IN THE FIGURES

In order to prepare formal drawings and correct inconsistent reference number usage therein, Applicant has amended Figures 8A, 8D, 8G, 9A, 9G, 9I, 10A, 10D, 10E, 11C, 13A, and 18D as described below and indicated on the annotated version of the drawings attached hereto as Exhibit 2.

Appl. No. 09/896,695
Amdt. Dated **10/20/2003**
Reply to Office Action of 06/20/2003

METHOD AND APPARATUS FOR PUSH BUTTON RELEASE FIBER OPTIC MODULES

FIG. 8A

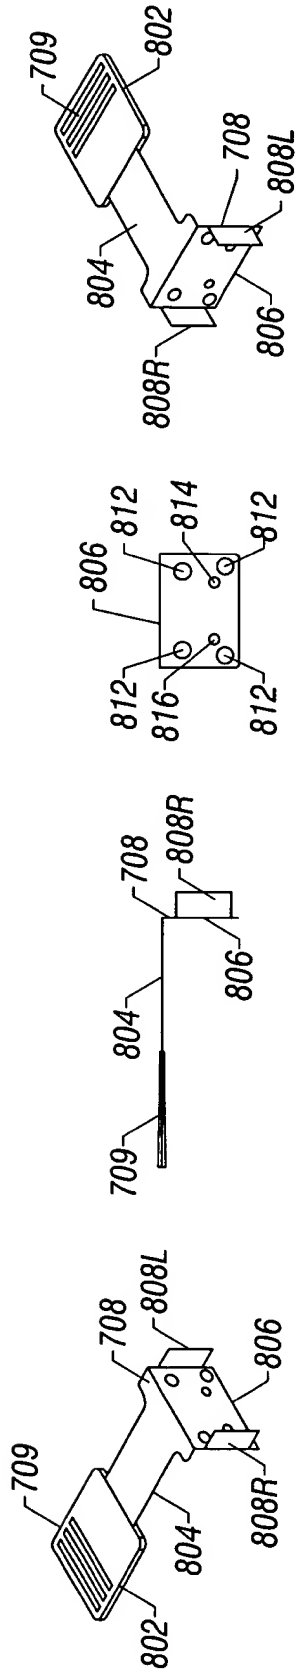
Figure 8A, Applicant has deleted the text "EMI SHIELD" from the drawing.

FIG. 8D

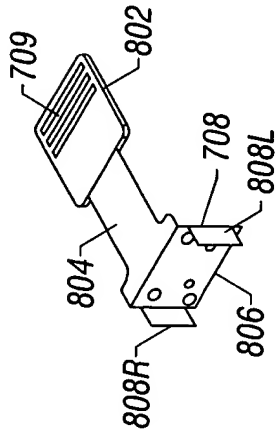
Figure 8D, Applicant has deleted the text "FLEXIBLE ARM" from the drawing.

FIG. 8G

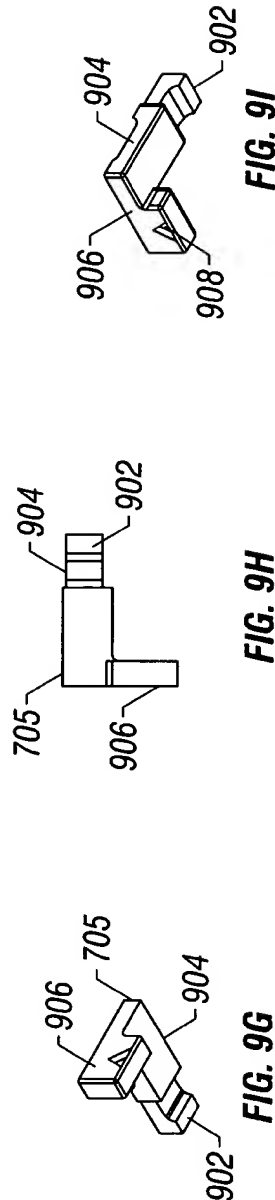
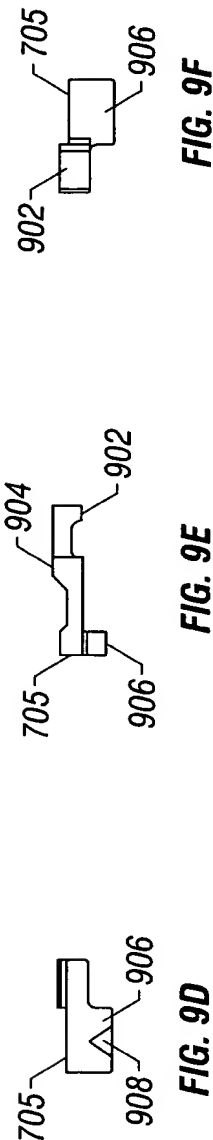
Figure 8G, Applicant has deleted the text "RUBBERIZED GRIP" from the drawing.

FIG. 11C

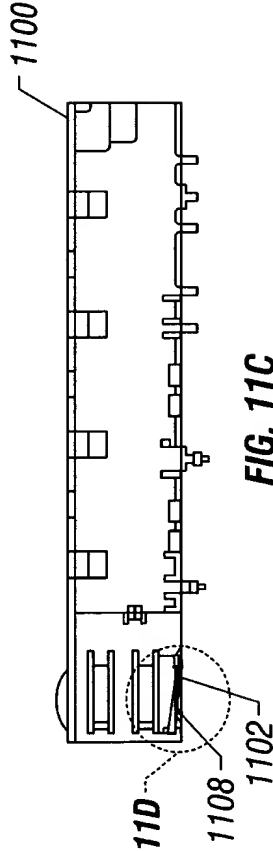
Figure 11C, Applicant has deleted the text "BOTTOM CAGE" and its reference line from the drawing. Applicant has further added a reference number 1108 consistent with the reference number 1108 shown in Figures 11B, 11D, and 11E.

FIG. 18D

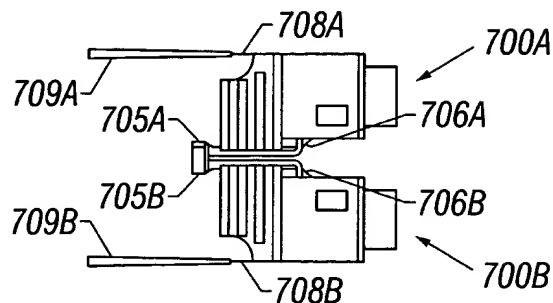
Figure 18D, Applicant has amended a reference number "708A" to --709A-- to correct an incorrect reference number. Reference number 709A is an optional pull grip of the withdraw tab 708A.

FIG. 10A

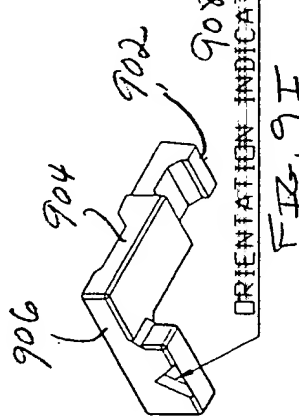
Figure 10A, Applicant has deleted the text "(1) ACTUATOR-KICKER" from the drawing.

FIG. 10D

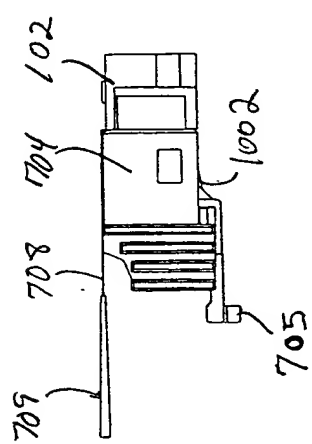
Figure 10D, Applicant has deleted the text "(3) NOSE GRIP" from the drawing.

FIG. 10E

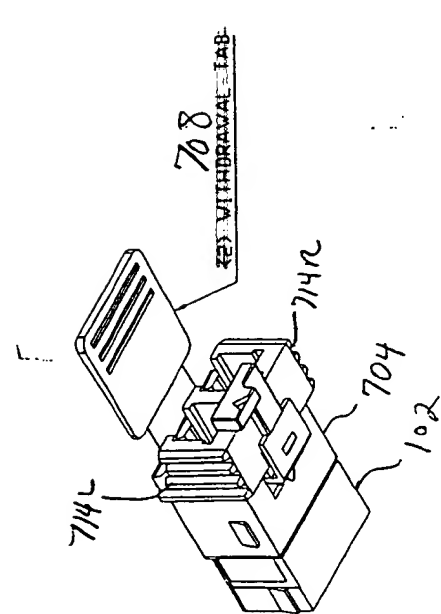
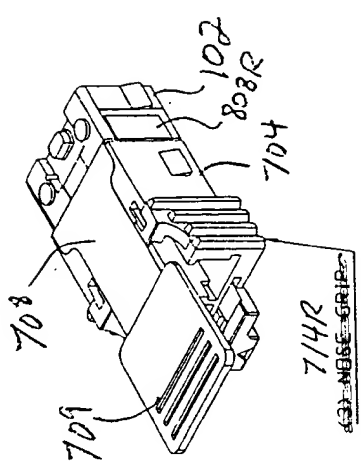
Figure 10E, Applicant has deleted the text "(2) WITHDRAWAL TAB" from the drawing.
